BURGER KING - STORE #3099 REMODEL

BLOOMINGTON, MN

PL202300039 PL2023-39

ARCHITECTURAL SITE PLAN

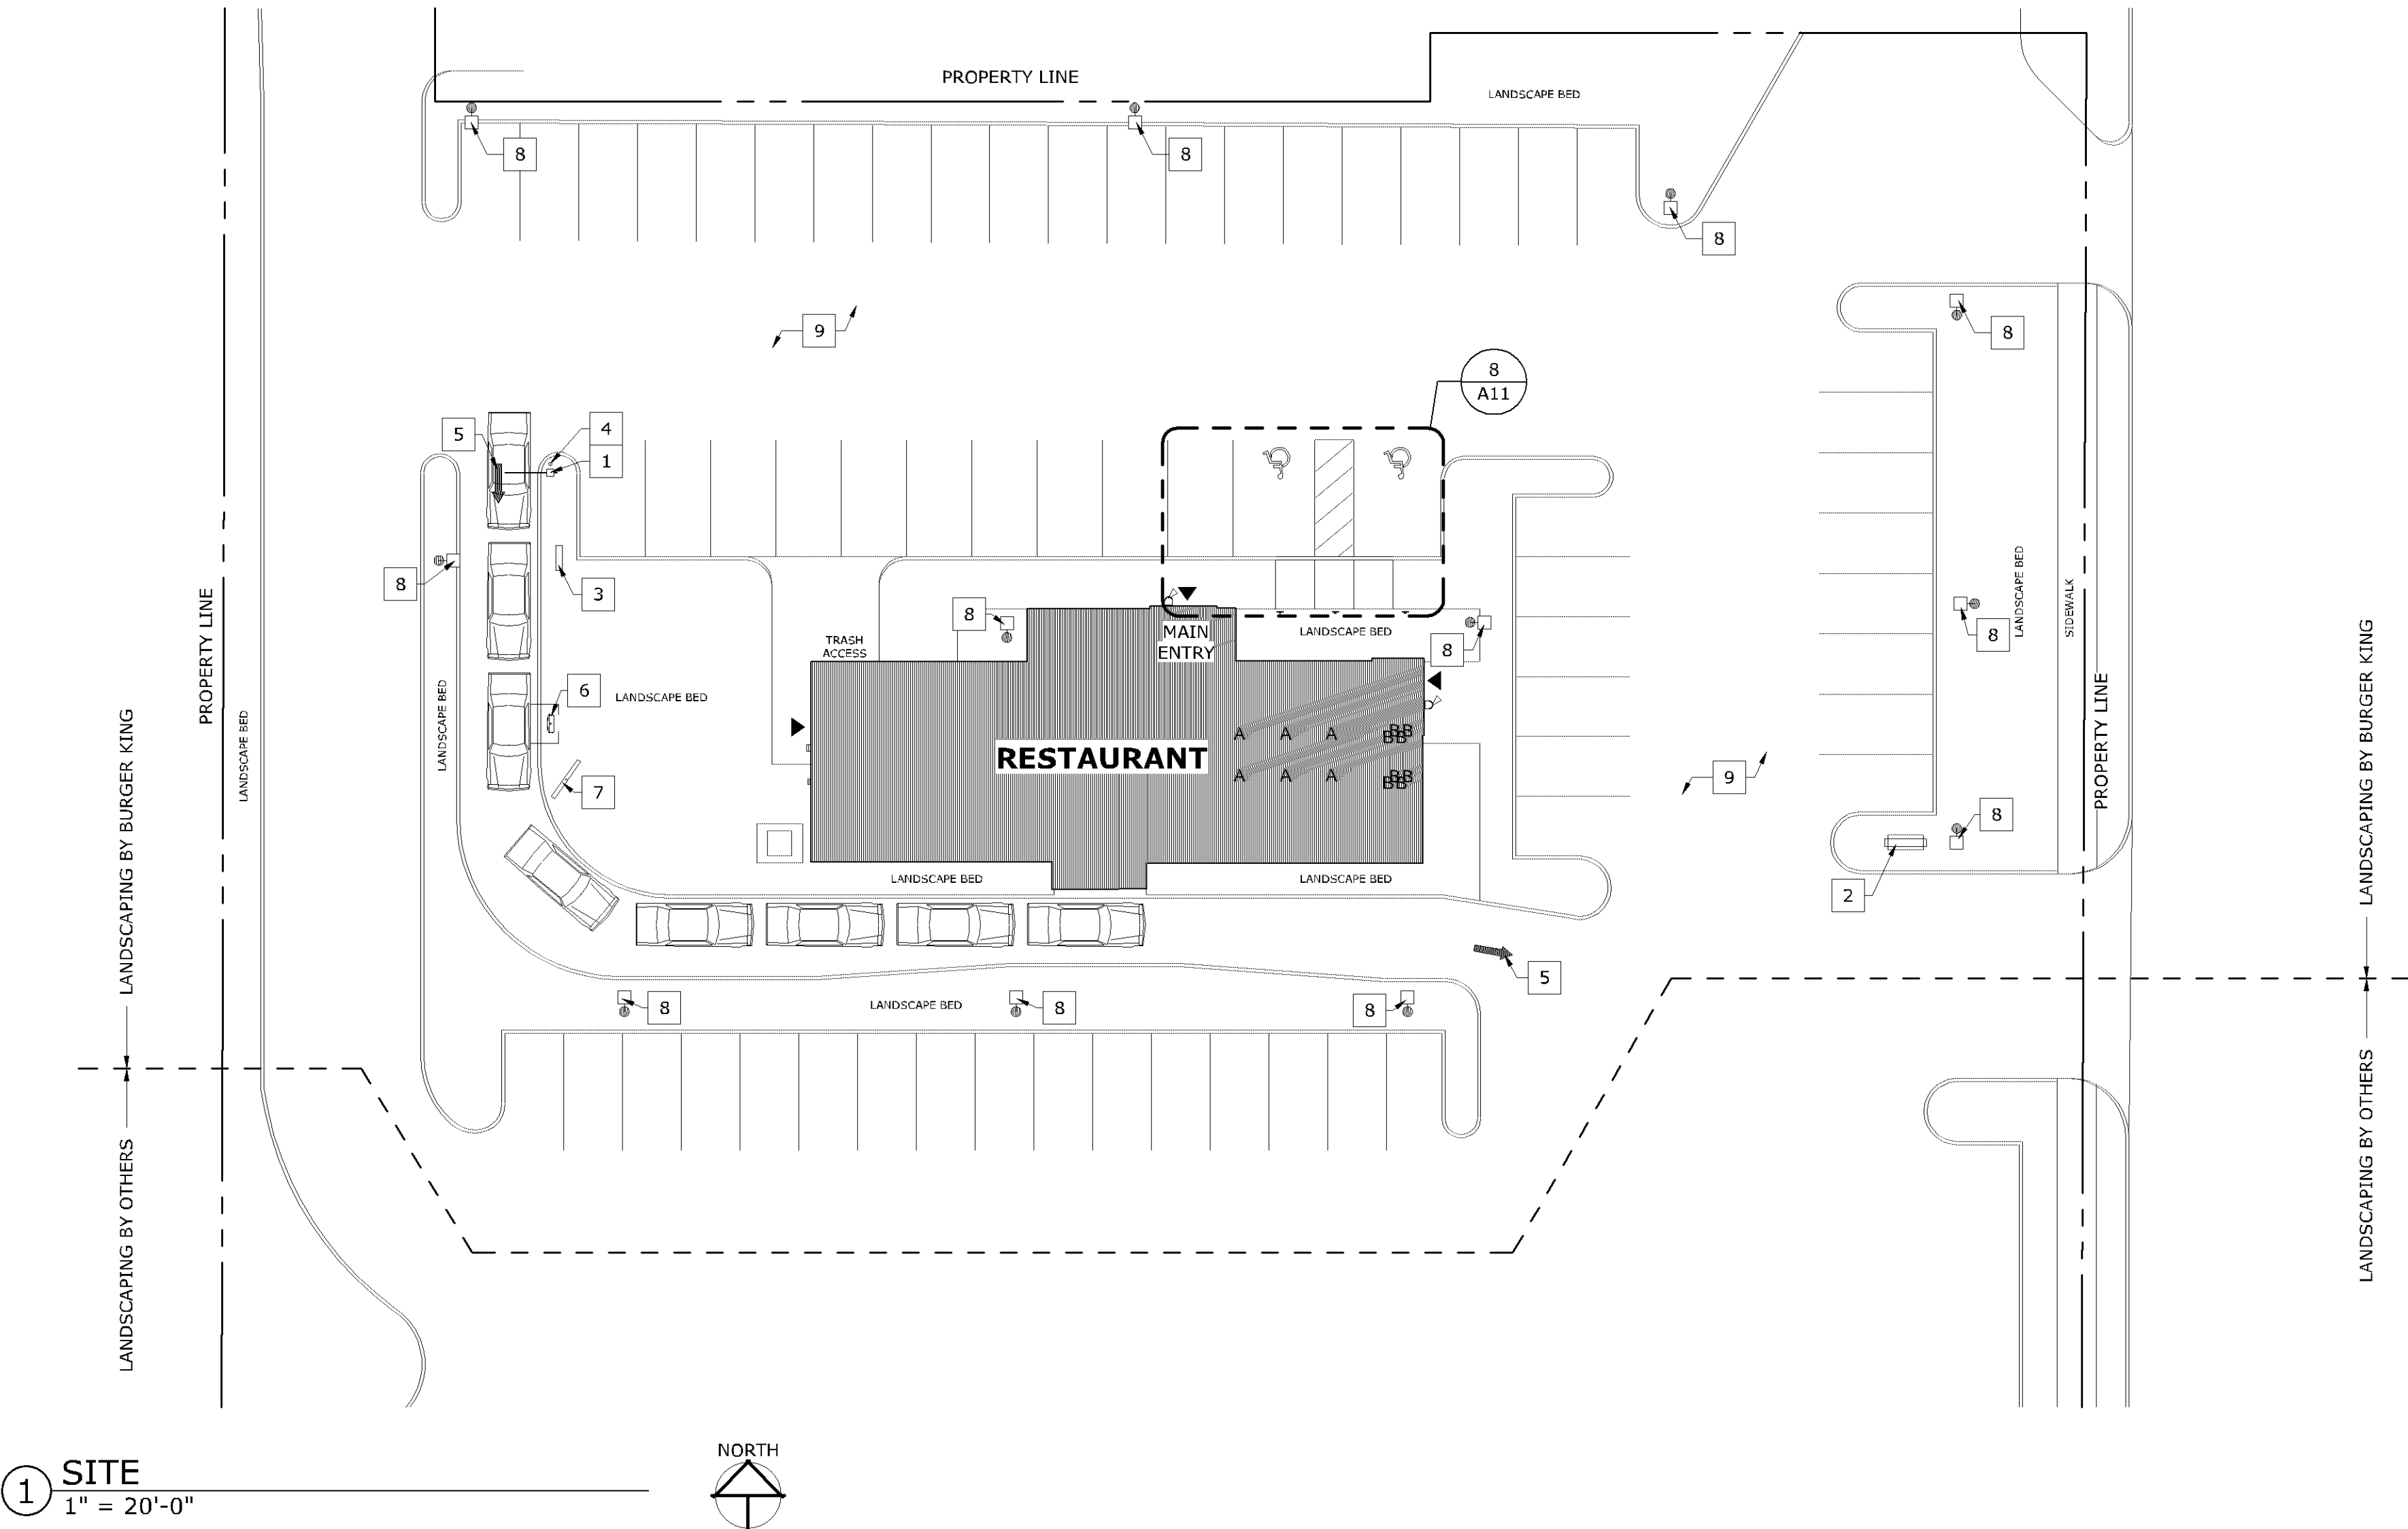
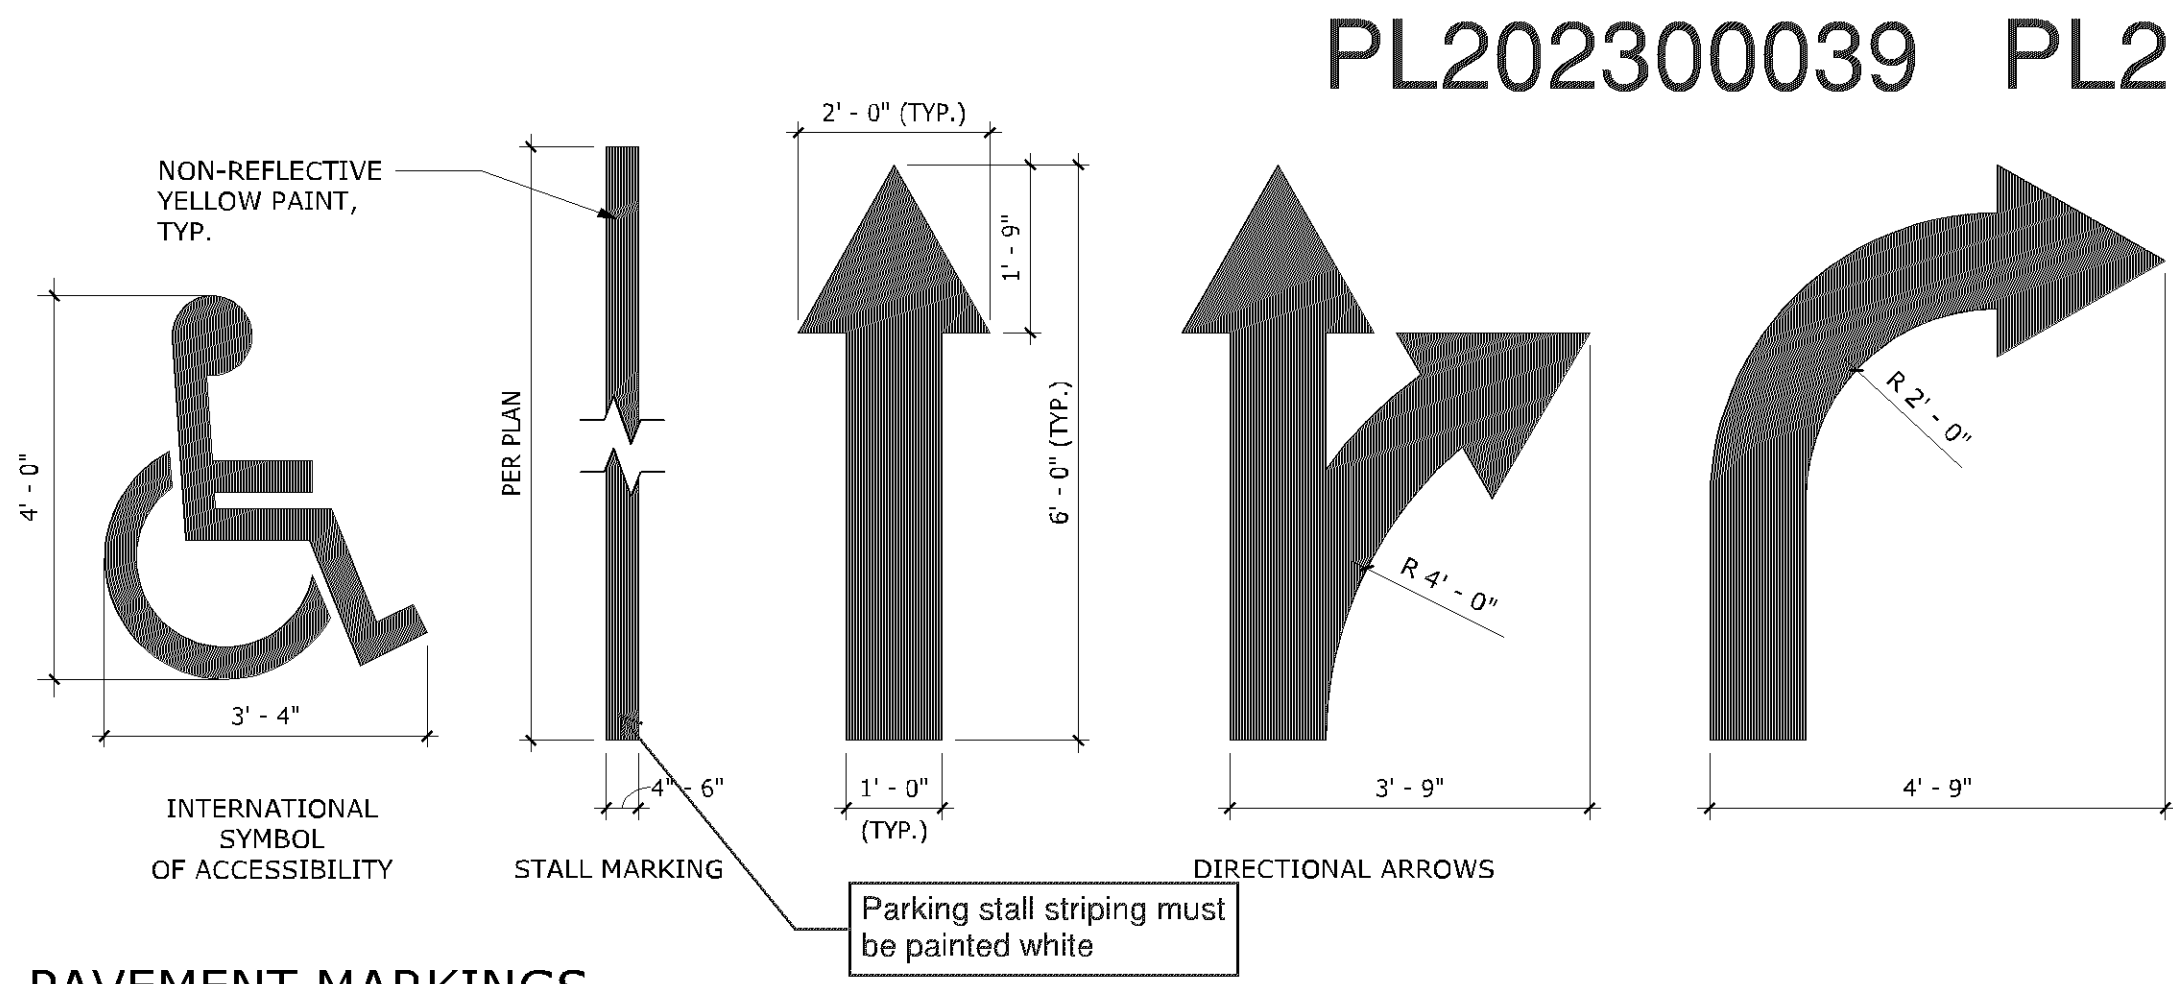
It appears many of the required landscape material has been removed over time. Any removed or deceased material as identified on the approved landscaping plan (available on the portal) must be replanted.

1 FLOOR PLAN
3/16" = 1'-0"

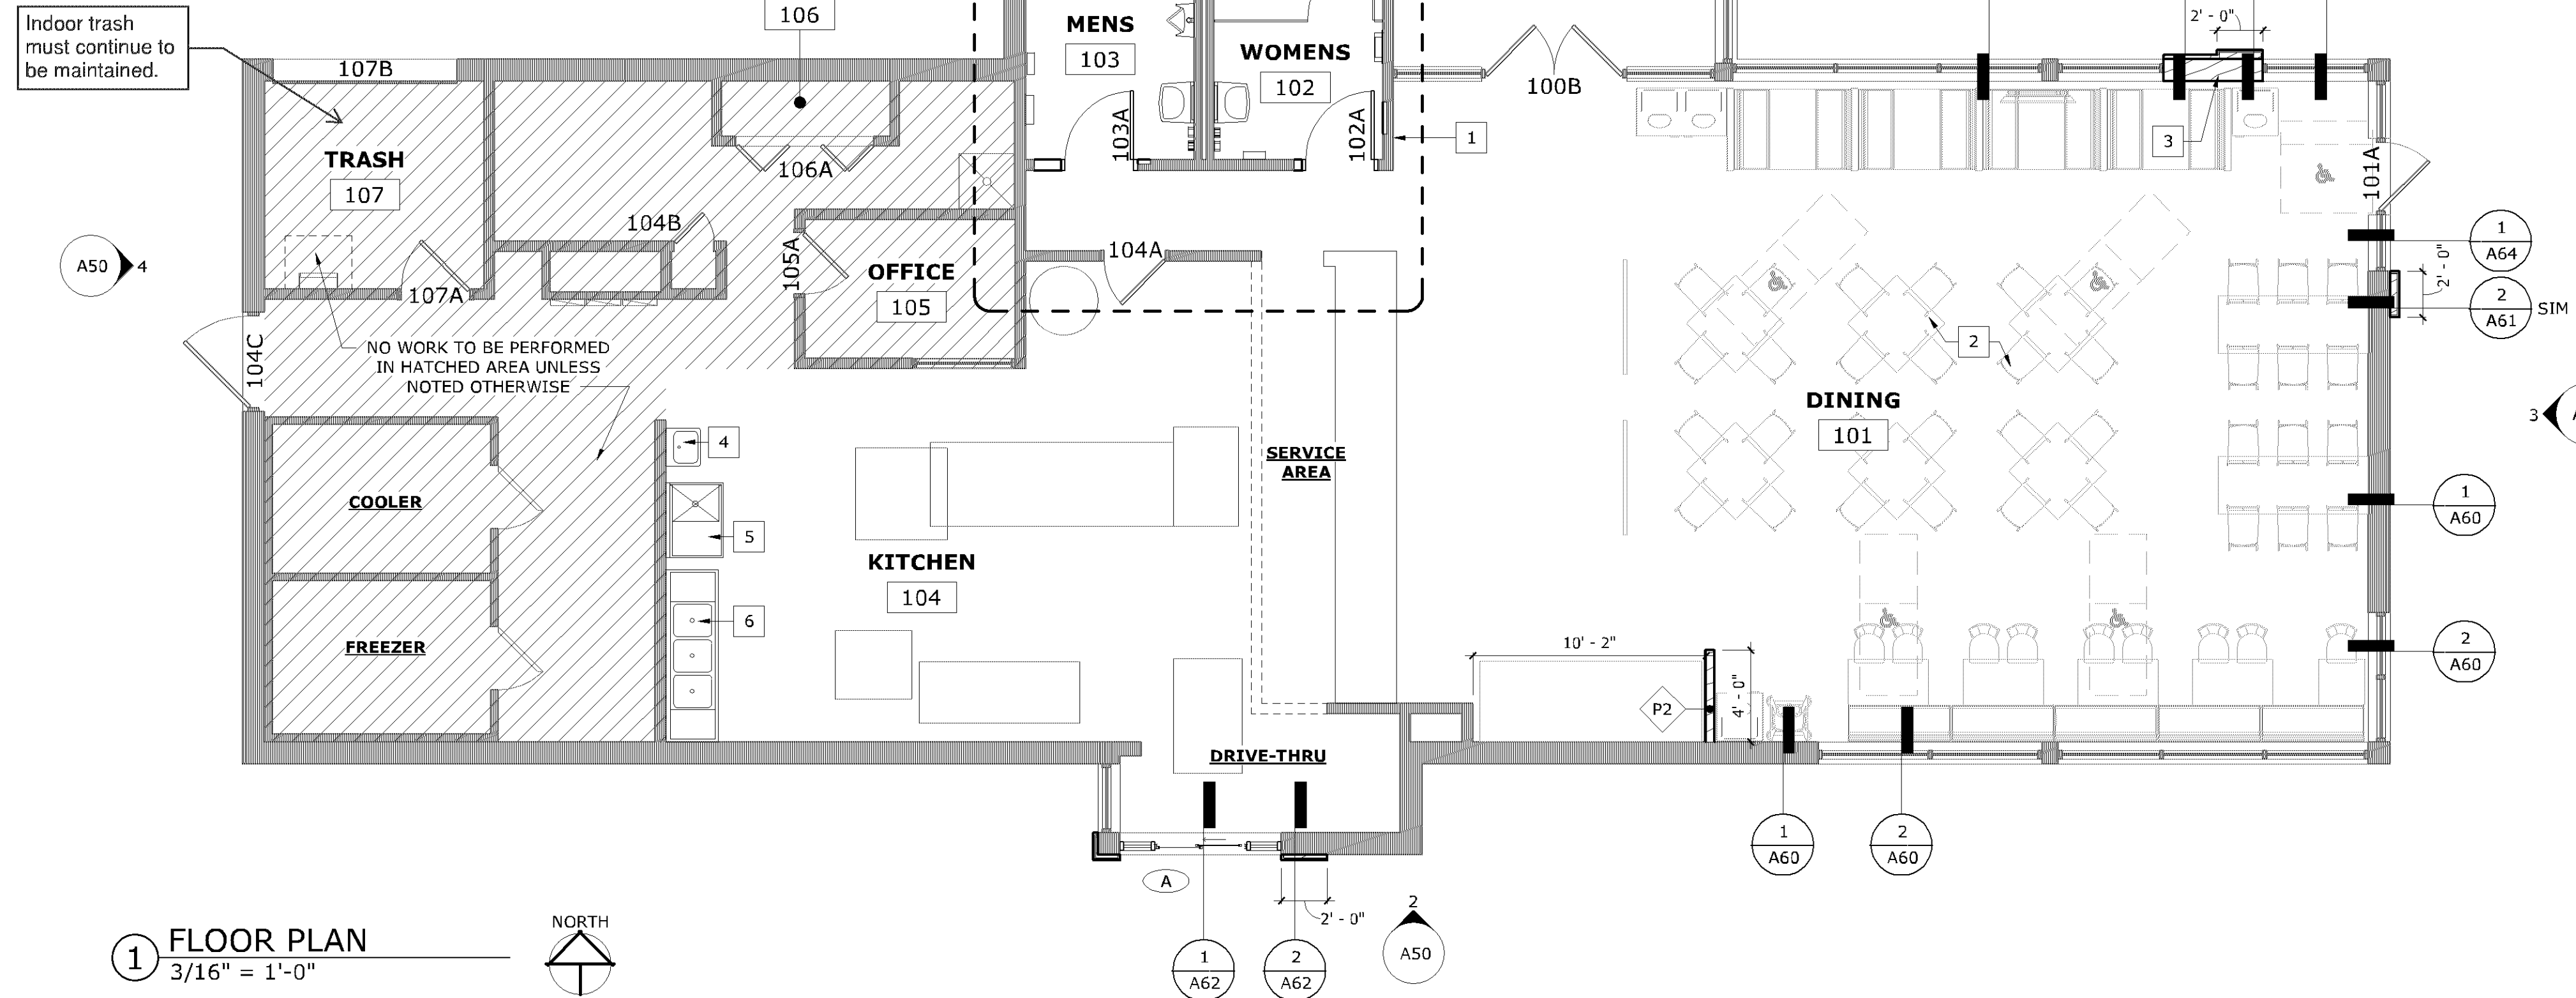
Provide an Environmental Health Plan Review application with plan submittal for each proposed food facility.

Provide specification sheets during plan submittal on all new and used equipment being proposed for use in this facility.

Any additions or changes to food service must be approved by the Health Department prior to construction if required.

Indoor trash must continue to be maintained.

Kitchen hood suppression shall be code complying and connected to the sprinkler system.

1 MAIN ENTRY ELEVATION
3/16" = 1'-0"

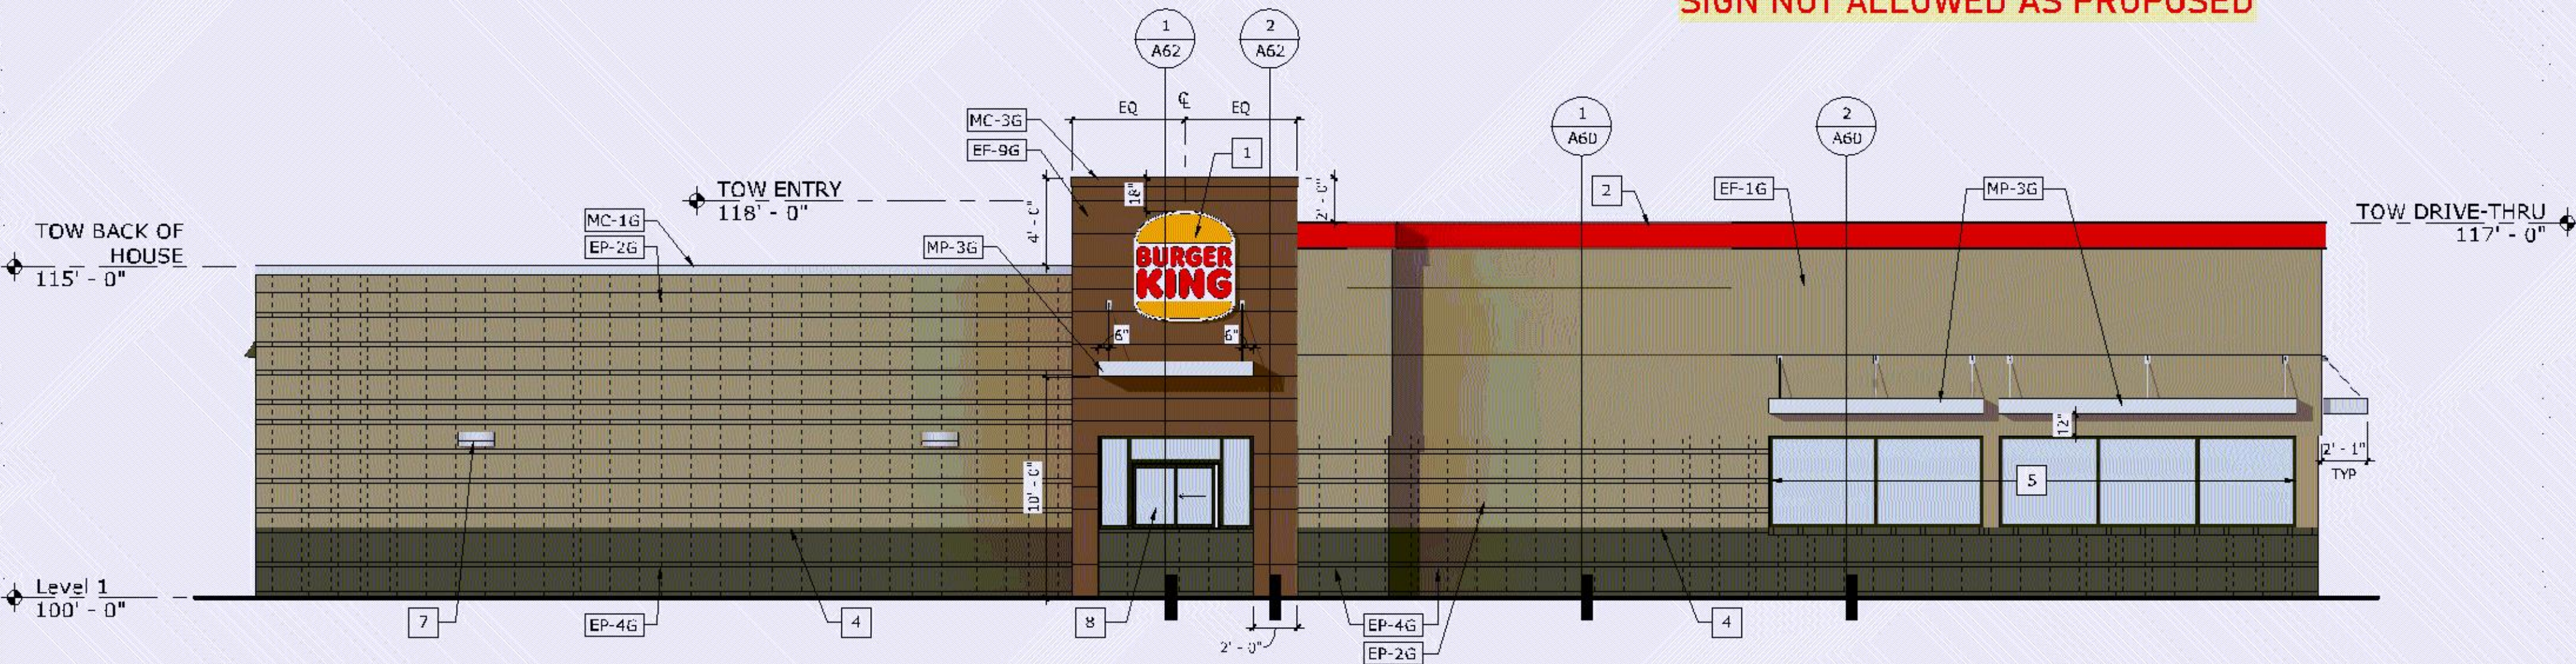
"Home of the Whopper" sign is considered signage and included in the overall allocation of signage square footage. Mixing cabinet and channel letter construction is not allowed.
SIGN NOT ALLOWED AS PROPOSED
